ARMY AVIATION TEST BOARD FORT RUCKER ALA
PRODUCT-IMPROVEMENT TEST OF IMPROVED DOOR LATCHES FOR OH-6A HEL--ETC(U)
MAR 68

SUBJECT: Final Report of Test, "Product-Improvement Test of
Improved Door Latches for OH-6A Helicopters,"
USATECOM Project No. 4-6-0251-07.

Figure 1. Improved door latch
for the OH-6A.

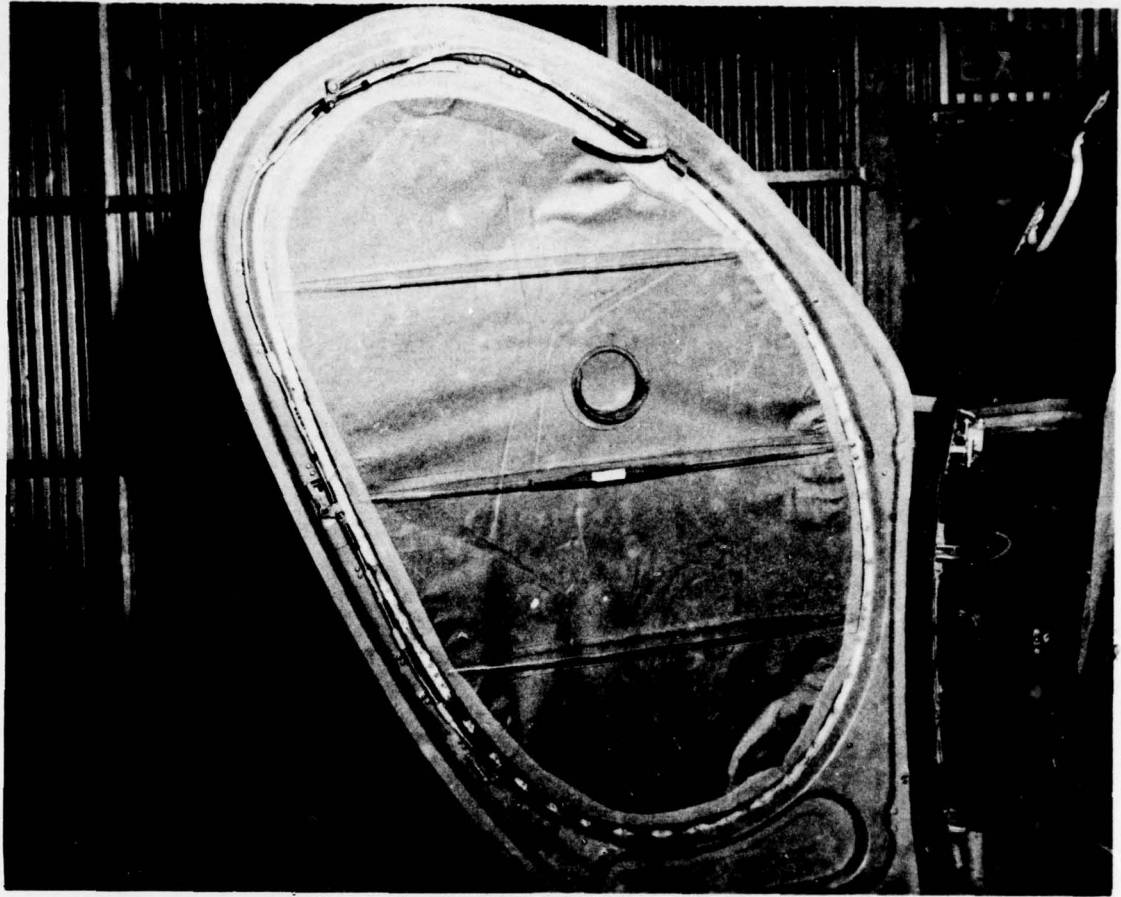
4. Description of Materiel. The test door latches (figure 1, inclosure) provide four adjustable lever latches constructed from material which is heavier than that originally used. The latch cable is

Figure 2. "Stop" (A) for inside handle and rubber dust boot (B).

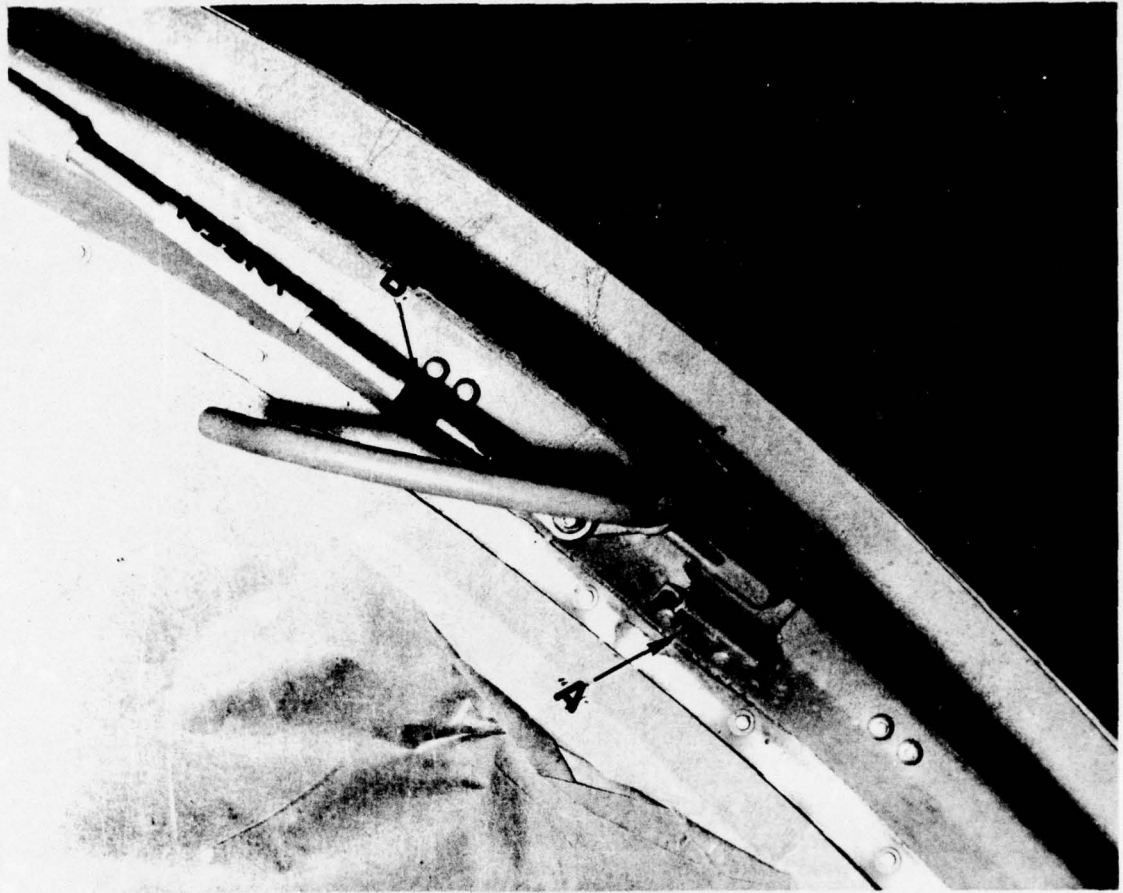
d. During installation of the door latches, the manufacturer's representative installed a "stop" for the inside handle (figure 2, item "A"). This "stop" prevented the handle from traveling past the center (open) position, thereby precluding overstressing of the cable.

e. The rubber dust boots on the ends of the conduit (figure 2, item "B") were not bonded in place and could be inadvertently displaced.

8. Recommendation. It is recommended that the improved door latch mechanism, modified to incorporate bonded dust boots and a "stop" for the inside handle, be installed on production aircraft doors.
